# CITY OF OAKLAND

### Planning Commission Design Review Committee

Subject: Proposal at 2201 Valley Street – Continued from August 8, 2018 Design Review Committee Meeting;

# 2201 Valley

CONTEXT VIEW

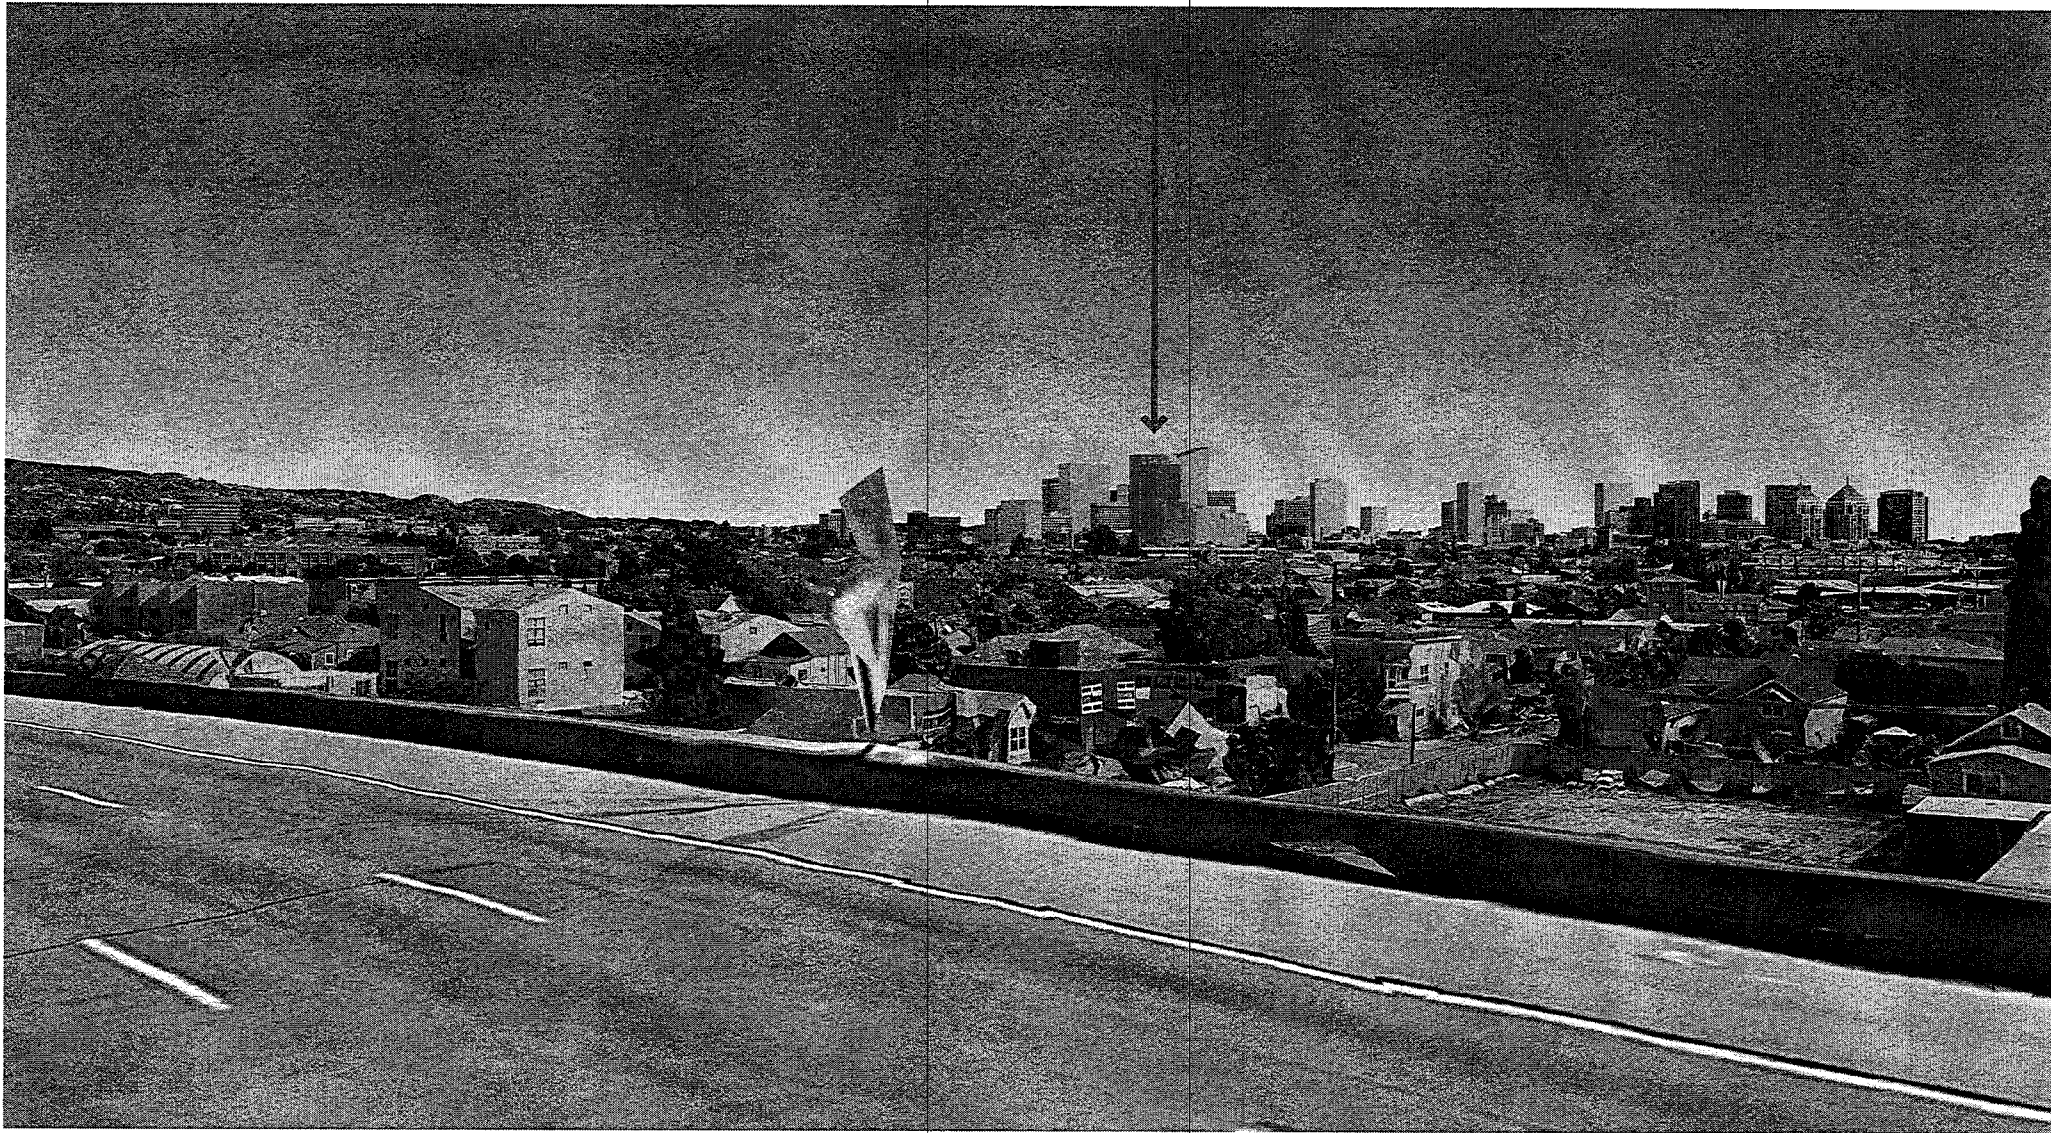
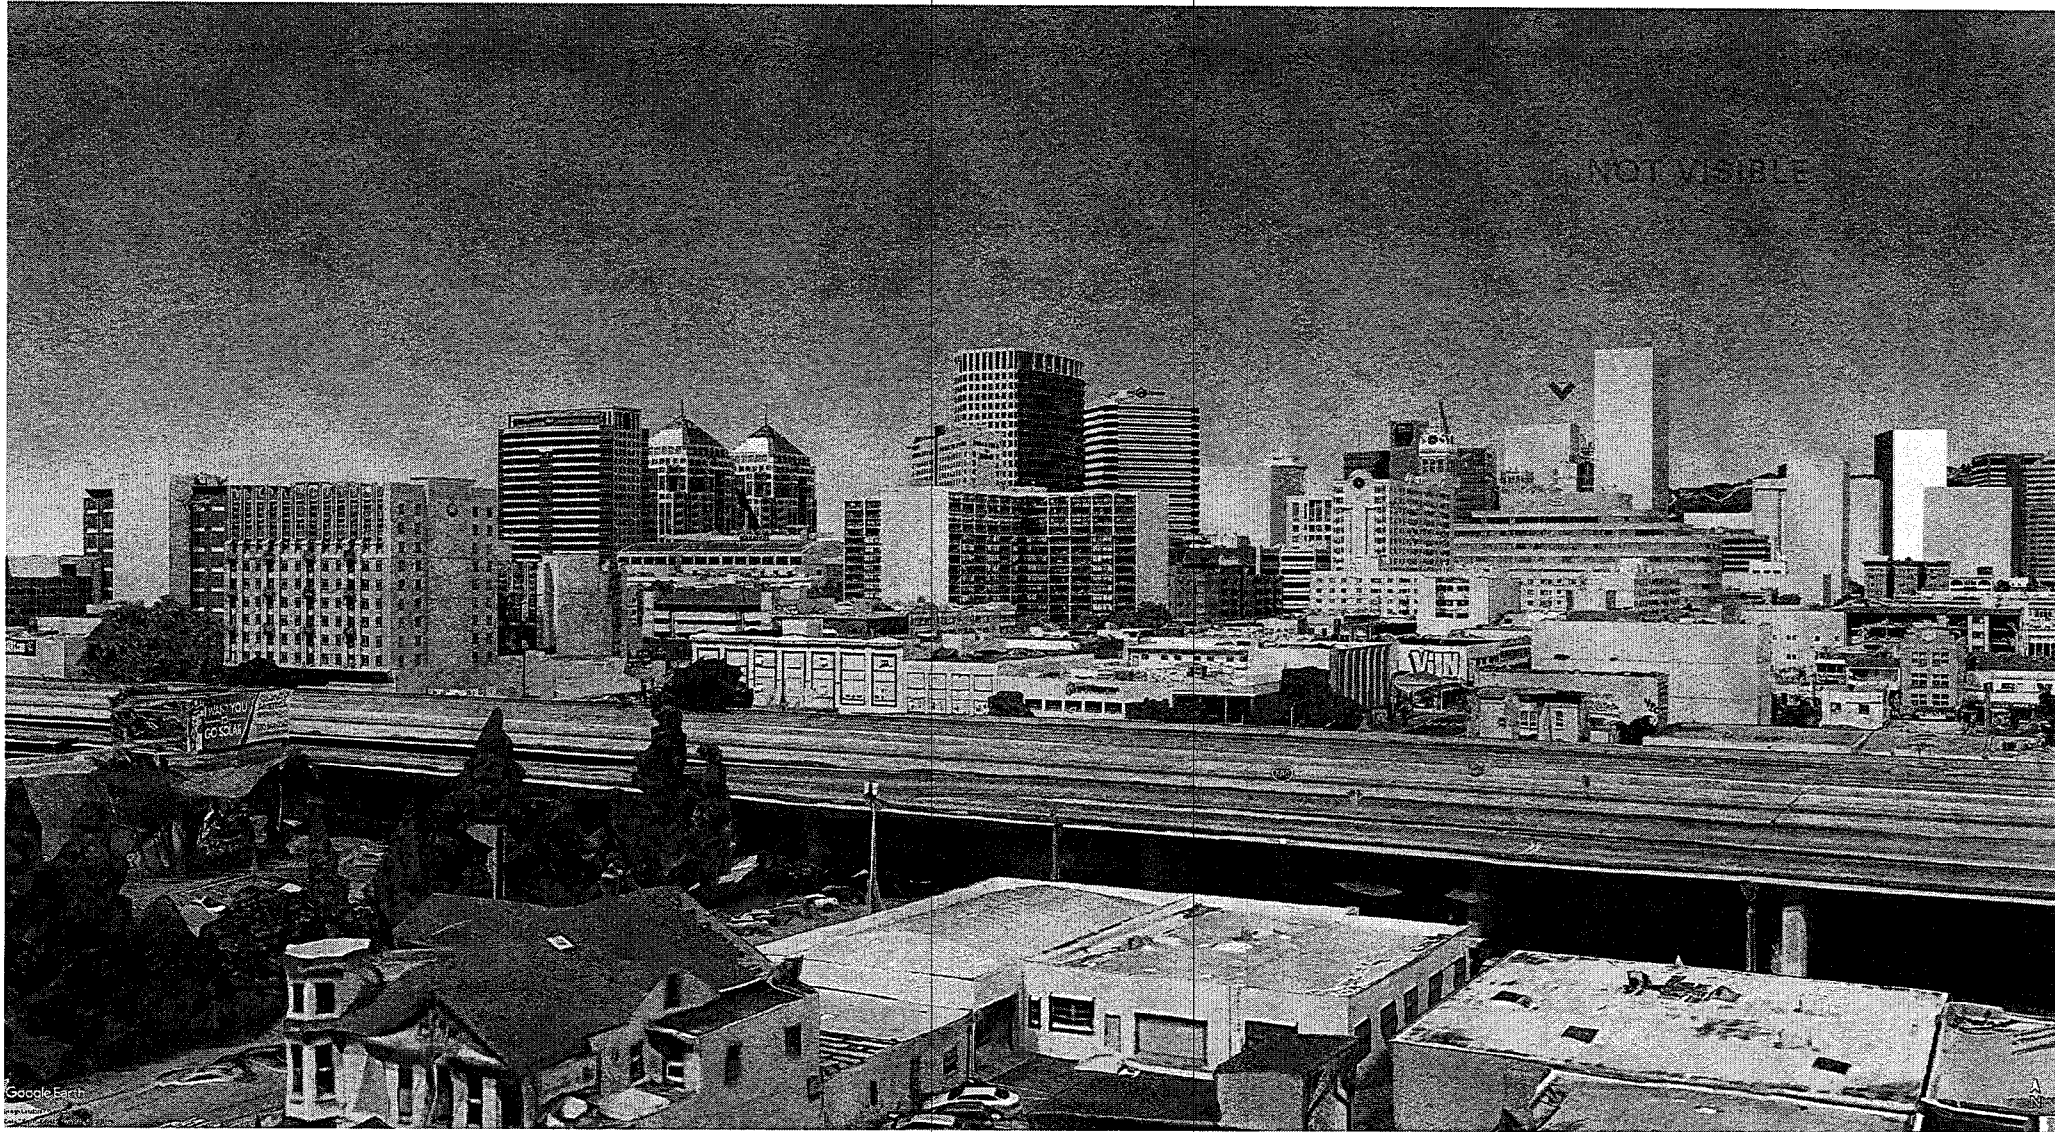
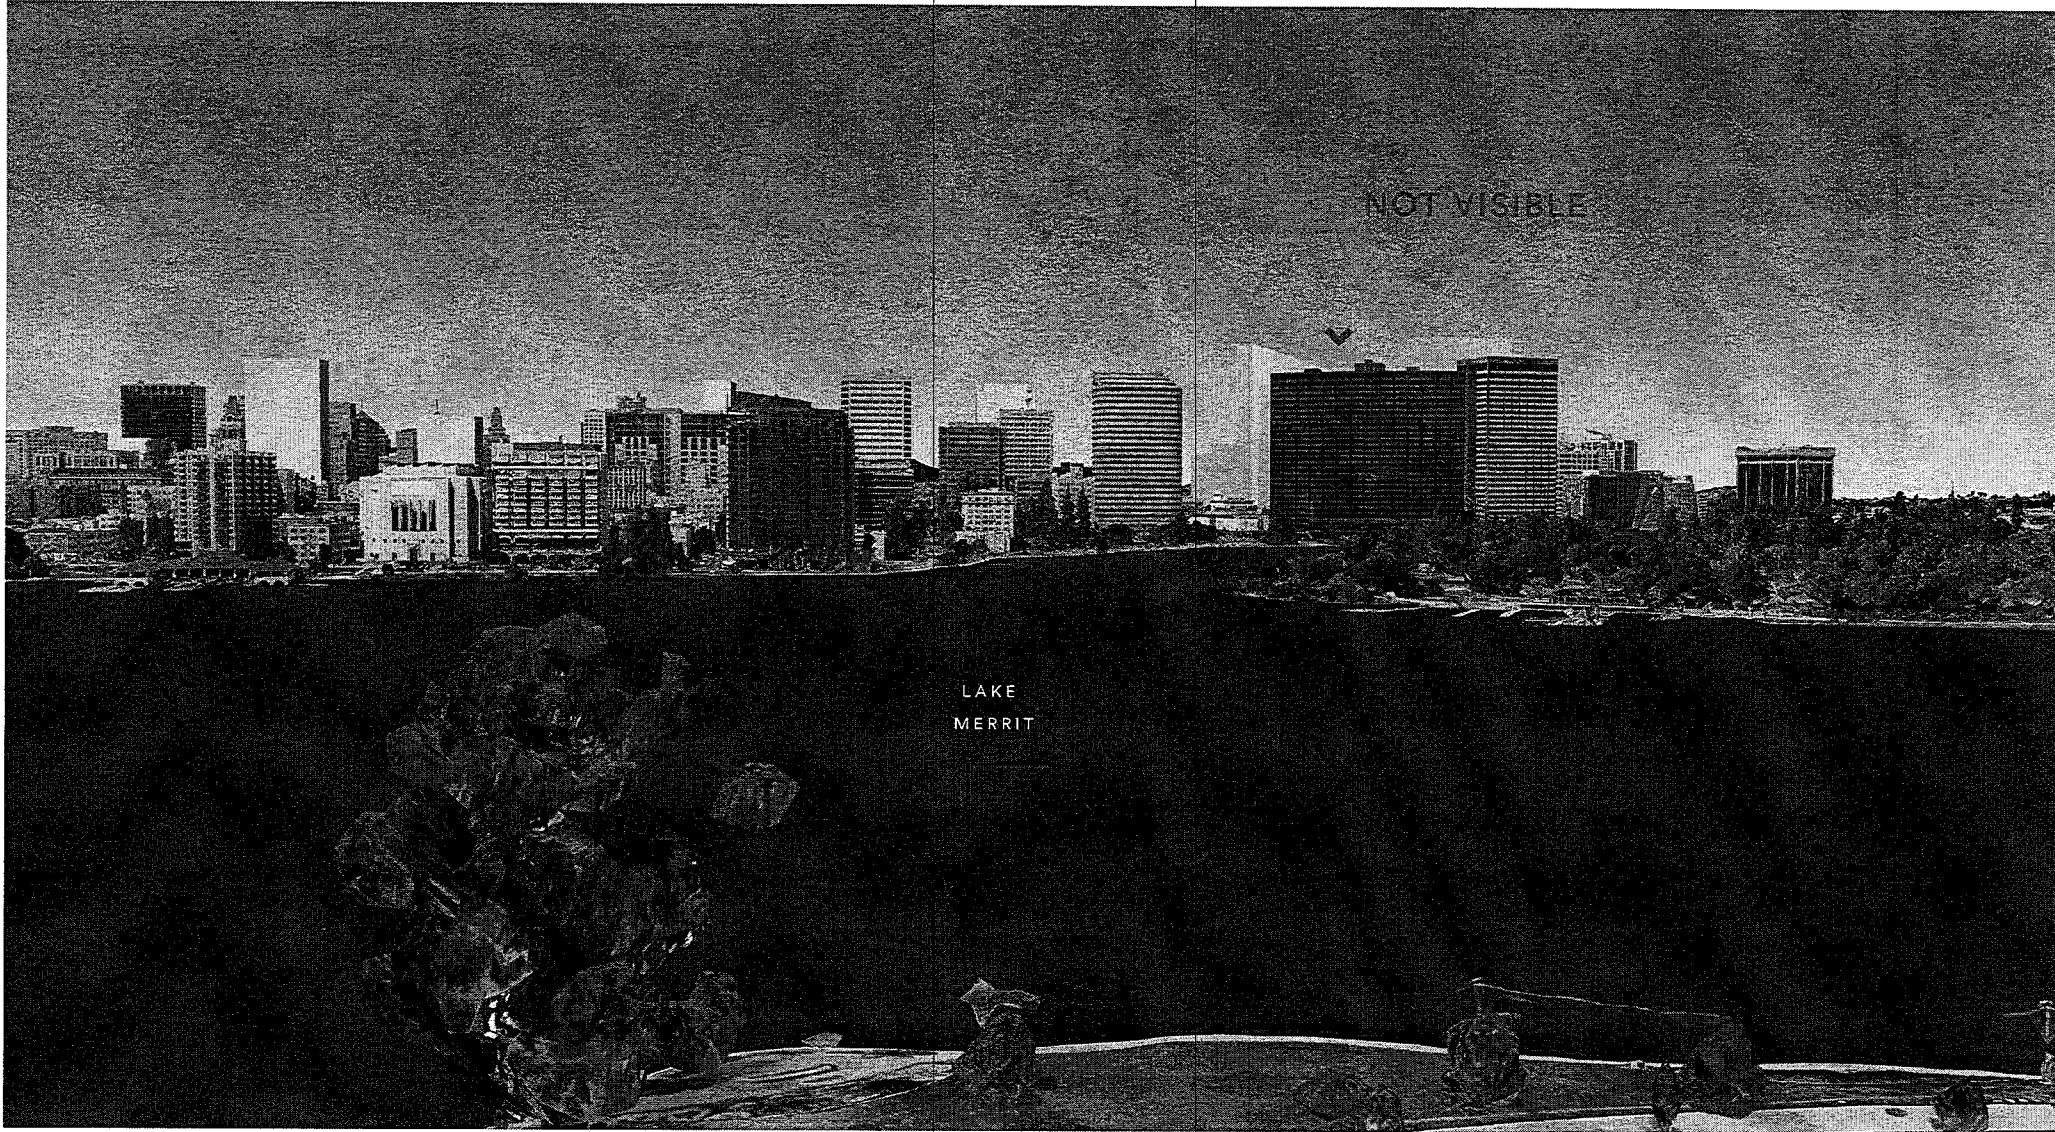
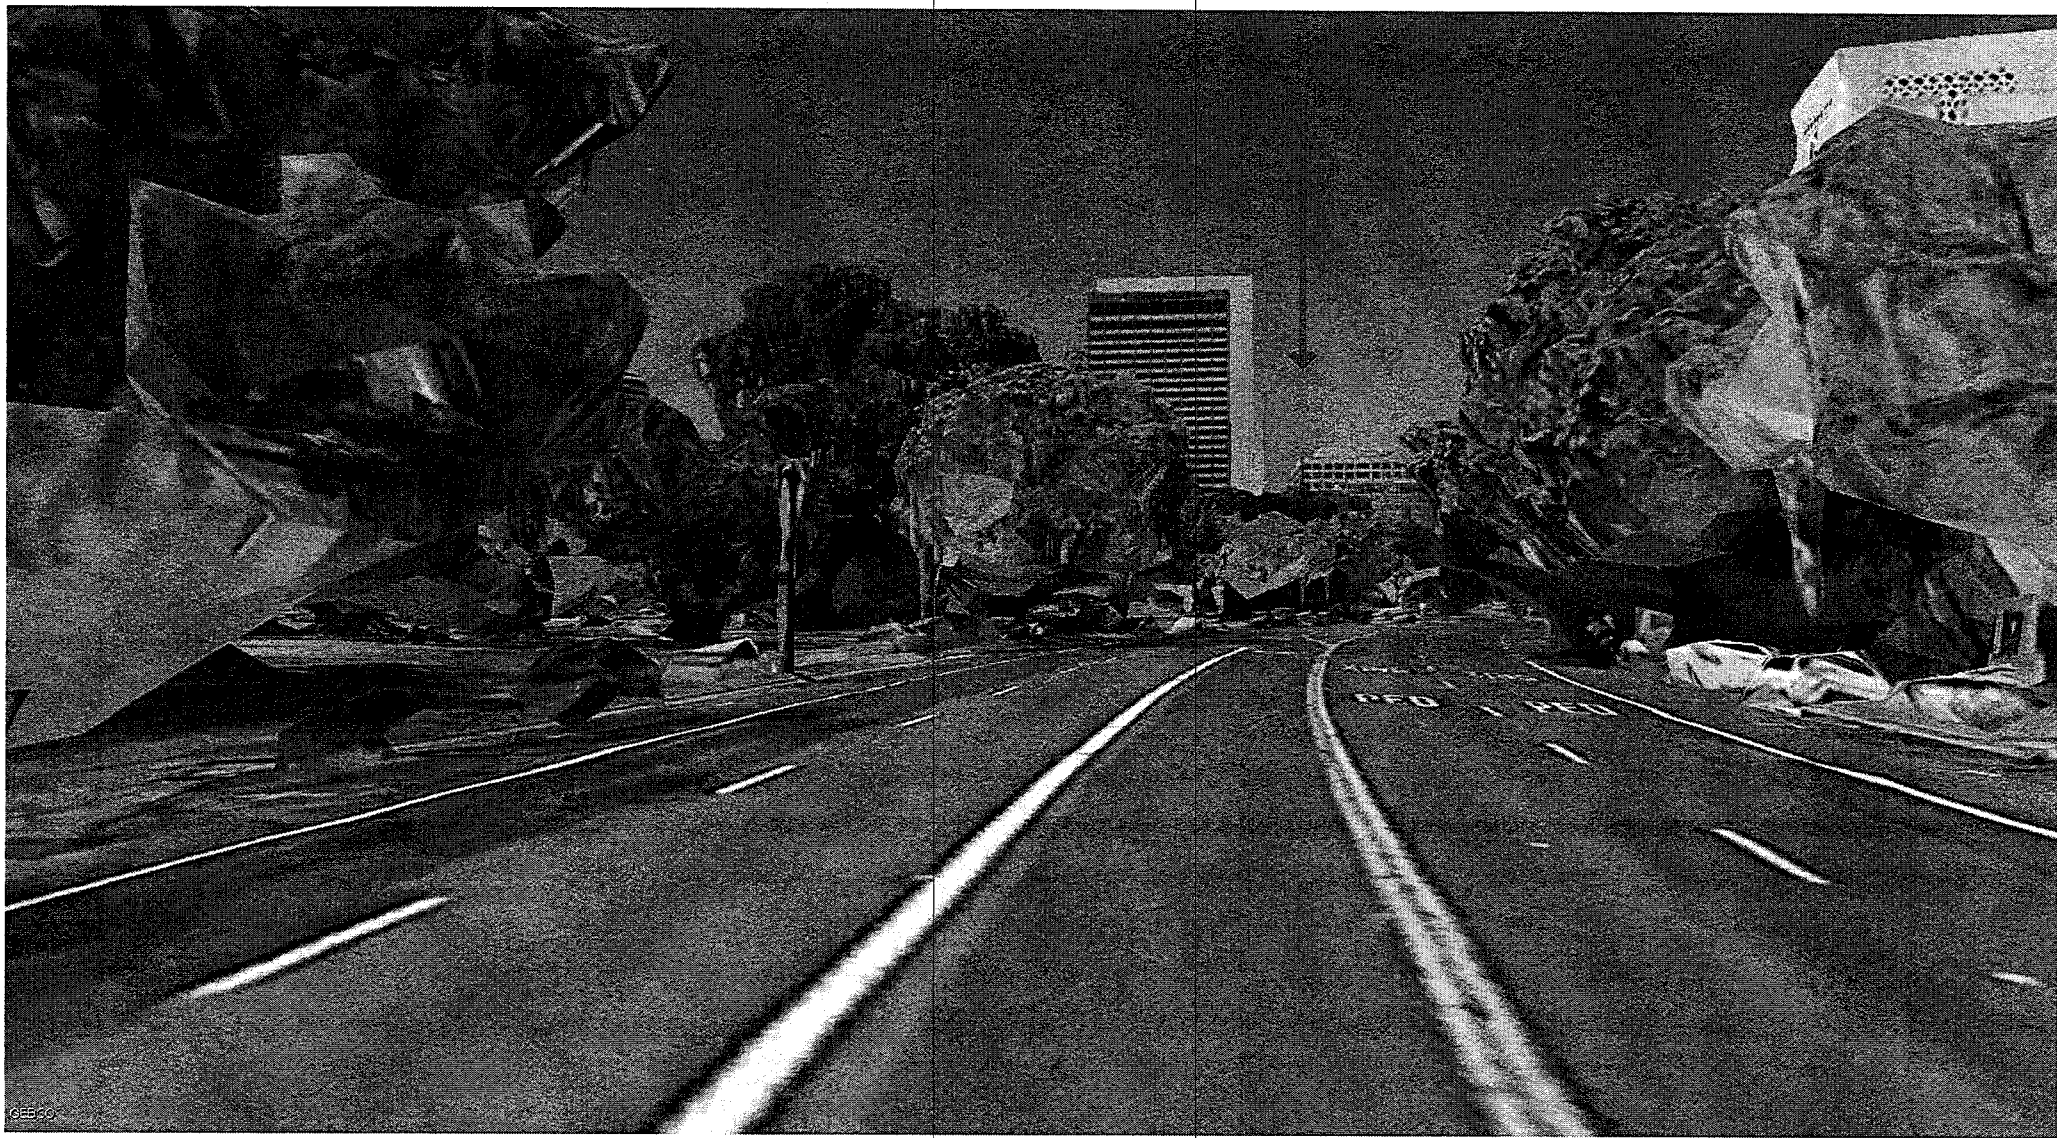
At the prior meeting comments were made about the compatibility of the proposal within the context of the surrounding area as well as the overall skyline view from a distance. The applicant has provided additional images in the plan submittal for consideration and comment.
